| Dist | COUNTY | ROUTE | POST MILES TOTAL PROJECT | SHEET No. | TOTAL SHEETS |
|---|---|---|---|---|---|
| 12 | Ora | 1 | 22.0/29.9 | 54 | 126 |

1 **REPLACED PER ADDENDUM No. 1 DATED SEPTEMBER 15, 2016**

# MODIFYING EXISTING ELECTRICAL SYSTEM

**E-3**

**REVISED STANDARD PLAN RSP ES-2E**

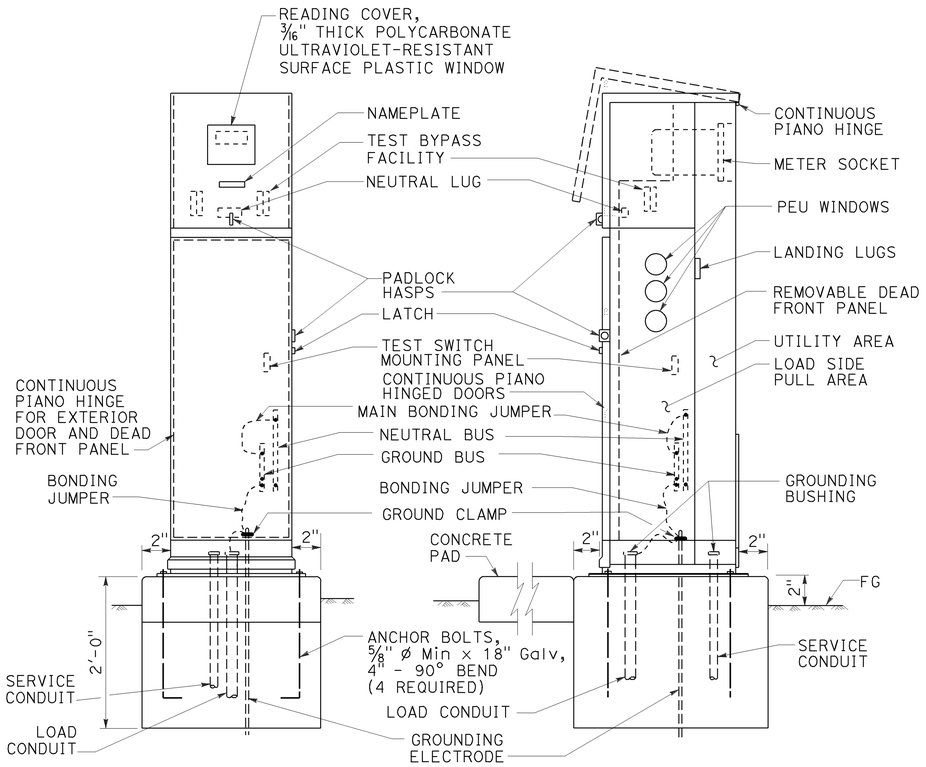
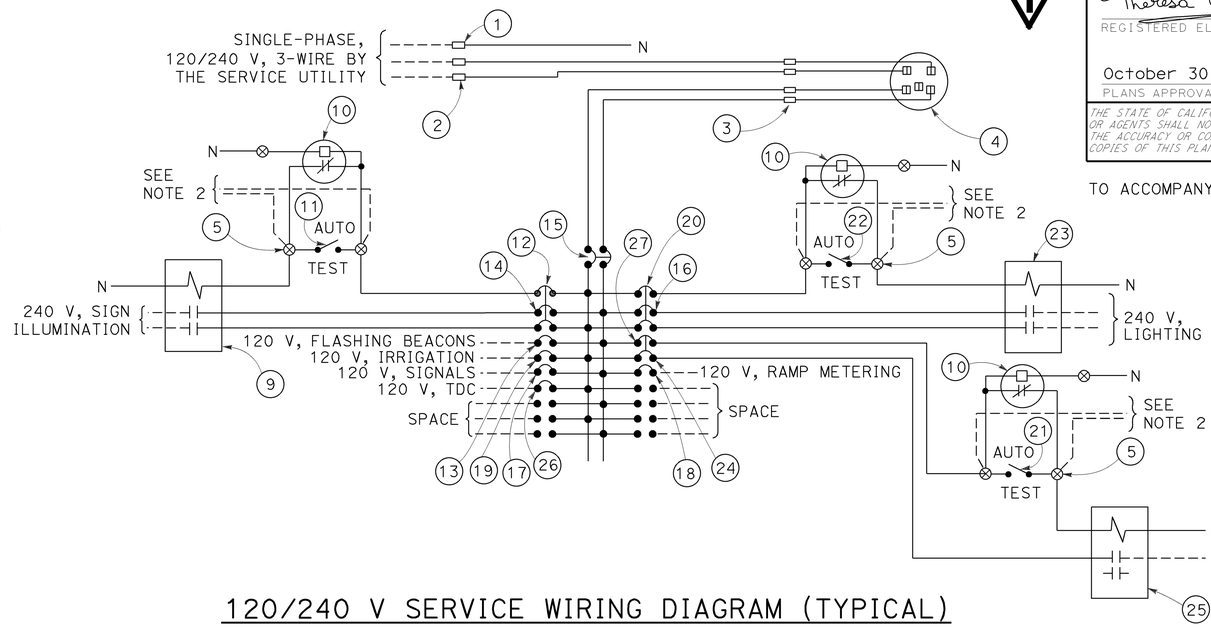
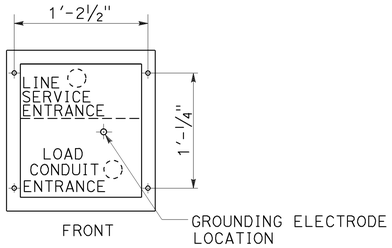
**1 ADDED PER ADDENDUM No. 1 DATED SEPTEMBER 15, 2016**
